**SUNDRY NOTICES AND REPORTS ON WELLS**  
*Do not use this form for proposals to drill or to re-enter an abandoned well. Use Form 3160-3 (APD) for such proposals.*

8. Well Name and No.  
N Escavada Unit 317H

Enduring Resources, LLC is requesting to expand their existing permanent facility area on the N Escavada Unit 315H, 316H, 330H, 331H well pad per the attached diagram. This well pad also serves as a remote facility to the N Escavada Unit 317H and 318H wells hosted on a separate location. A site visit was conducted on May 10, 2018 with Randy McKee to discuss facility expansion and related dirt work components required to accommodate interim reclamation at a later date. A brief summary of the facility changes to be made are listed below:

# Enduring Resources N Escavada Unit 315H, 316H, 330H & 331H Well Pad Diagram Section 10, T22N, R7W, NMPM, Sandoval County, New Mexico

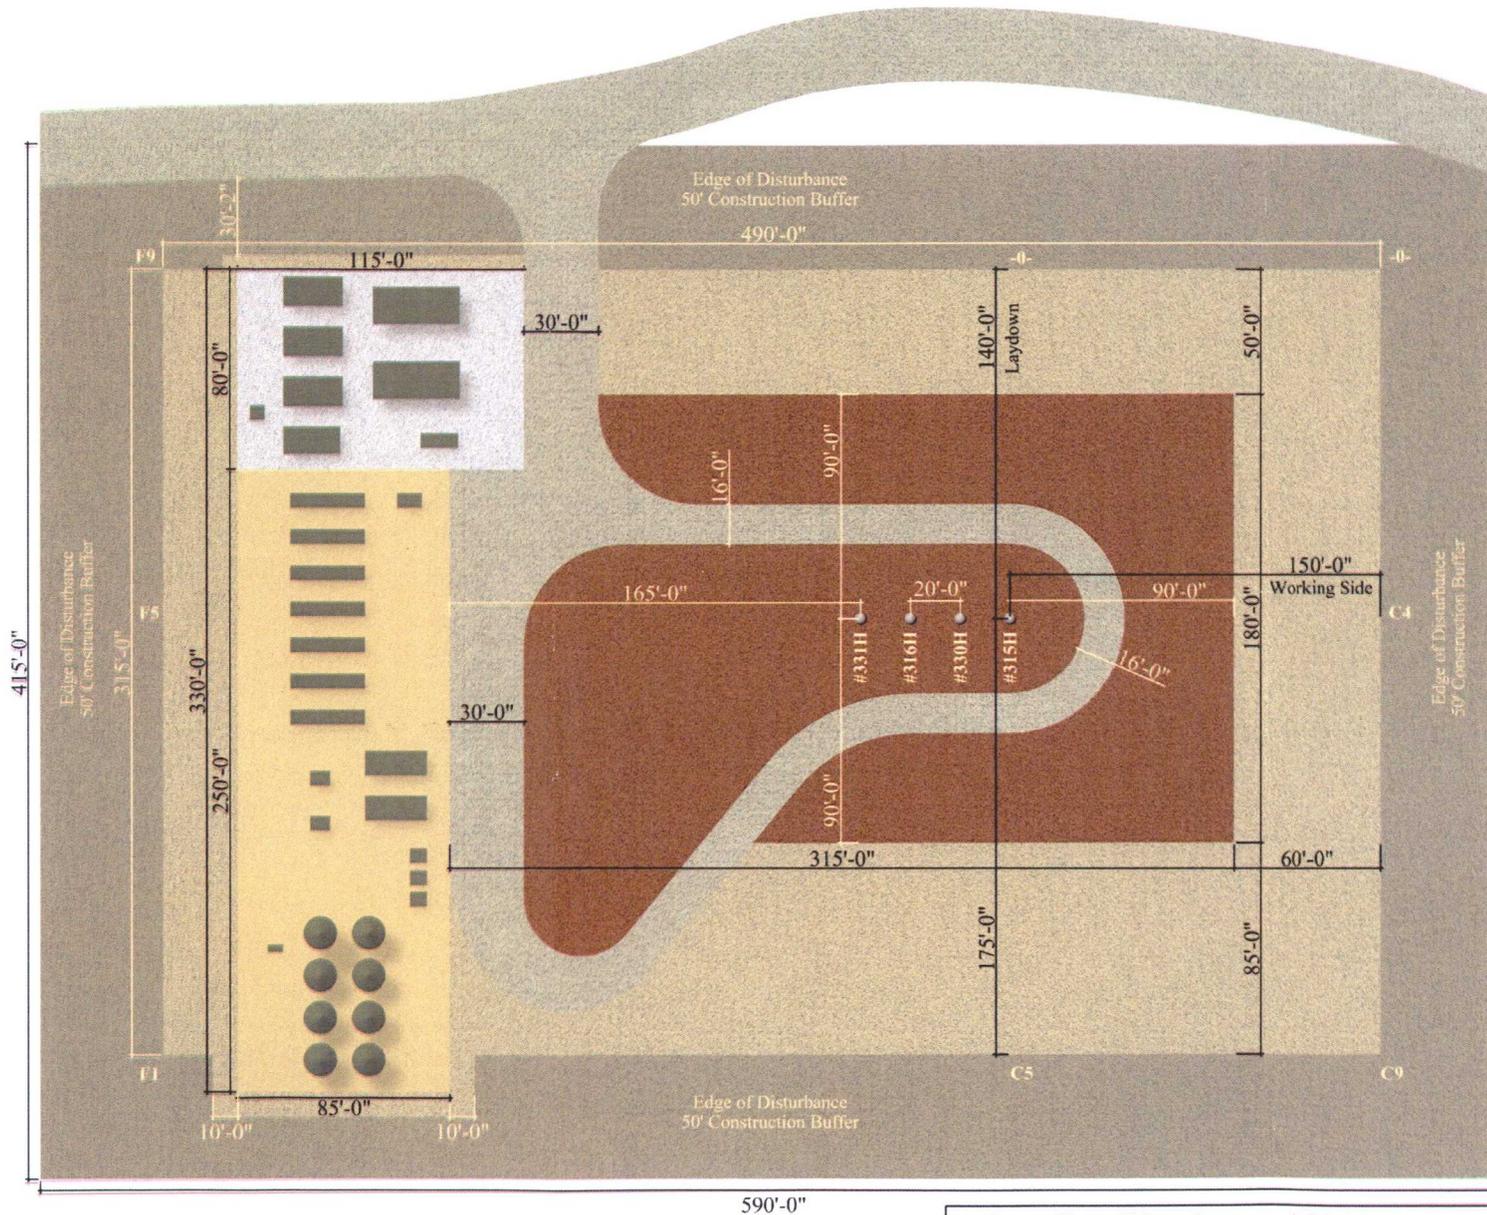
- Expand the pipe paneled area north of the containment an additional 30 feet north and 20 feet east. This will result in the paneled area being approximately 80 feet by 115 feet and a total facility area of 330 feet by 115 feet. This additional area will host an MCC building, three capstones, two compressors and other minor facility components and above ground appurtenances. Please see attached diagram.

- As a result of the facility expansion, the access road entering location would be shifted easterly to enter the location in front of the expanded facility area.

- The existing resource road adjacent to the well pad near the northwestern corner would be shifted approximately 12 feet north away from the fill slope of the well pad to allow for 3:1 interim reclamation of the slope at a later date.

- An existing culvert in the section of aforementioned resource road being moved, will be reset to accommodate the road change.
